Executive Director's Recommendation

Commission Meeting: February 6, 2020

PROJECT National Institutes of Health Master Plan Amendment National Institutes of Health, Bethesda Campus 9000 Rockville Pike Bethesda, Maryland	NCPC FILE NUMBER MP02 NCPC MAP FILE NUMBER 3101.20(05.00)45062 APPLICANT'S REQUEST Approval of comments on draft master plan amendment
SUBMITTED BY United States Department of Health and Human Services National Institutes of Health	PROPOSED ACTION Approve with comments
REVIEW AUTHORITY Approval of Master Plans for use by the Commission per 40 U.S.C. § 8722(a) and (b)(1)	ACTION ITEM TYPE Staff Presentation

NIH Master Plan Amendment

Conceptual Rendering – UVPPG (MLP 15)
North-East View (Elevator Lobby on Convent Drive)

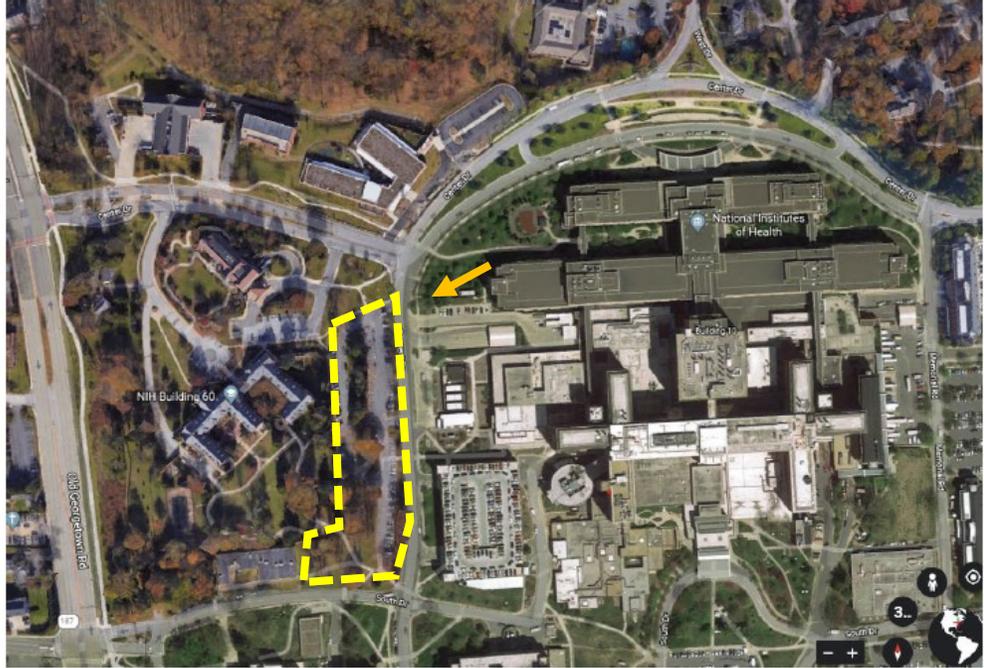
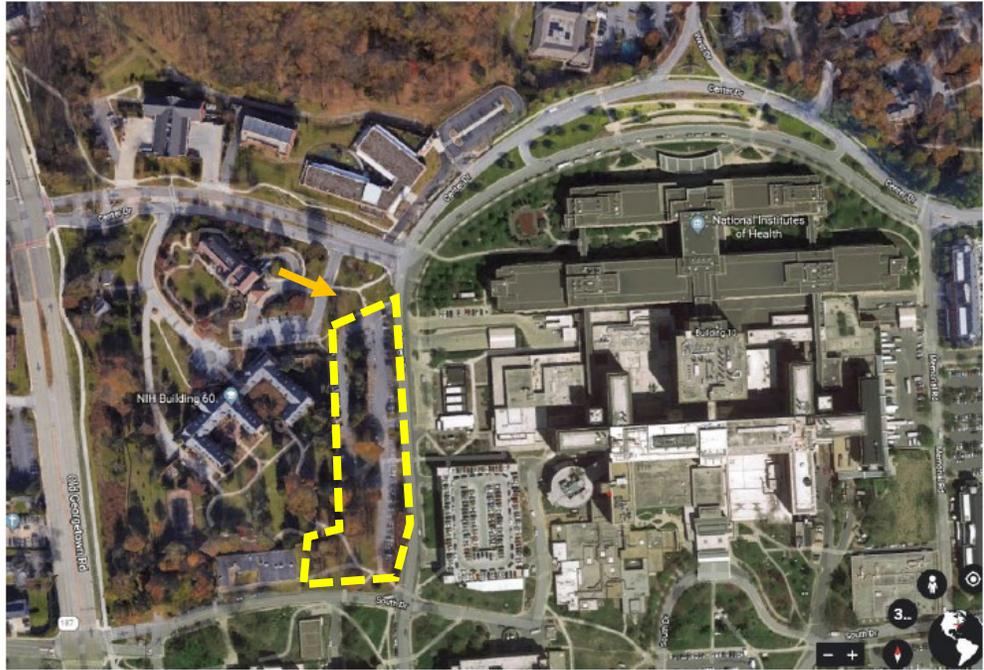
Finds that while structured parking is preferable to surface parking, the massing of the proposed garage at approximately 90 feet (6 stories) in height and 500 feet in length will have a significant impact on the views and setting of the Convent, and is likely to result in an adverse effect under Section 106 of the National Historic Preservation Act.

Recommends that NIH evaluate ways to reduce the visual impact of the new garage on the Convent property including modifications to the garage height and massing and the development of a robust landscape plan should NIH submit the project for future review.

NCPC Comprehensive Plan policies encourage structured parking rather than surface parking, and redevelopment of sites rather than developing on natural land. The proposed new garage is consistent with these policies. However, the structure will likely have significant adverse visual impacts to the adjacent Convent property with its six-level design (maximum height of 93 feet) and 500-foot length, creating a complete visual wall along the property's eastern edge. Additional landscaping may help partially hide the wall, but views of the garage looking east from the Convent will likely remain based on the large size of the structure. Therefore, staff recommends that the Commission **find that while structured parking is preferable to surface parking, the massing of the proposed garage at approximately 90 feet (6 stories) in height and 500 feet in length will have a significant impact on the views and setting of the Convent, and is likely to result in an adverse effect under Section 106 of the National Historic Preservation Act.**

Conceptual Rendering – SRLM
North-West View from Center Drive (Old Georgetown Road) Entrance

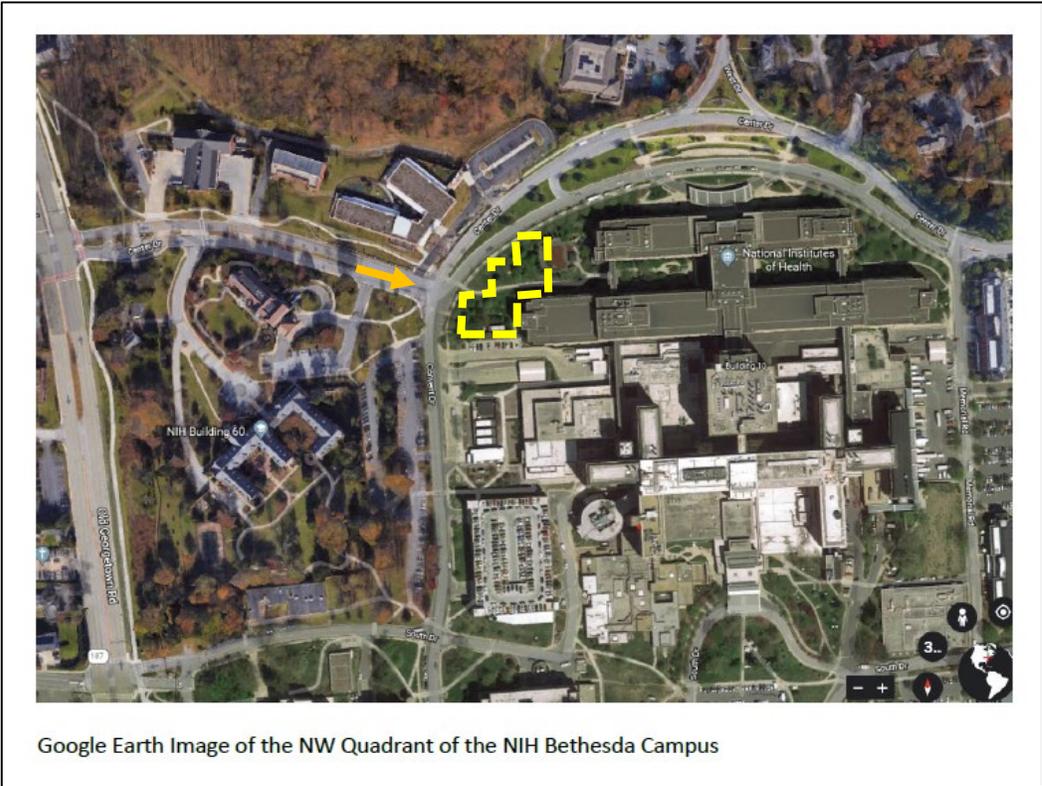
Supports the design approach as shown in the early renderings with windows, new entrances, landscaping and public space to differentiate this part of the building, and significantly smaller setbacks from the street to create a more urban environment.

The submission does not provide a lot of information regarding the new addition since NIH is still in the preliminary stages of design. However, the master plan amendment portrays the project as an eight-story structure in a “stepped” configuration, with approximately 527,000 square feet of interior space on the northwest corner of the existing CCC. The addition will move the building line to within 18 feet of Convent Drive, near the Convent Drive / Center Drive intersection, which serves as a vehicular entry onto campus for employees. The project will create a more dramatic, urban-like appearance to the campus upon entry, which is a change from existing conditions. Staff finds that the new SRLM will create additional visual interest when entering on to campus here, and the build-out will not adversely impact the overall appearance of the CCC, which is already a massive building complex. Therefore, staff recommends that the Commission **support the design approach as shown in the early renderings with windows, new entrances, landscaping and public space to differentiate this part of the building, and significantly smaller setbacks from the street to create a more urban environment.**
